World Forum for Harmonization of Vehicle Regulations

Proposal for Supplement 9 to the 07 series of amendments to UN Regulation No. 48 (Installation of Lighting and Light- Signalling Devices)

Submitted by the Working Party on Lighting and Light-Signalling*

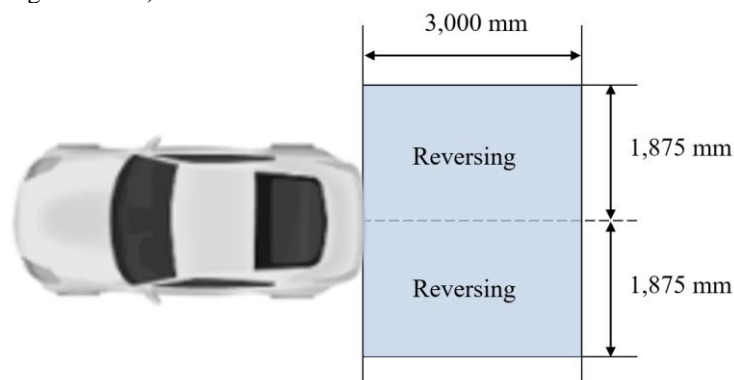
6.27.5.2. The patterns of the reversing projections shall start with their closest edge within a rectangle, symmetrical to the median longitudinal plane and adjacent to the extreme outer edge of the vehicle, having a length of 1,000 mm and a width of 3,750 mm (see figure below).

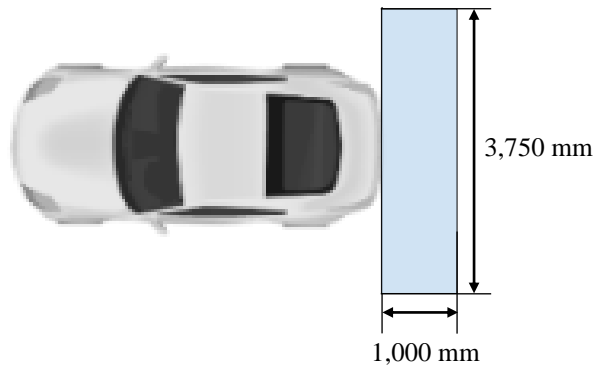
6.27.5.1. The lateral distance from the outer edge of the projection with respect to the longitudinal plane of the vehicle shall not be more than 1,875 mm.
The longitudinal distance from the farthest edge of the projection shall not be more than 3,000 mm from the backward extreme outer edge of the vehicle (see figure below).
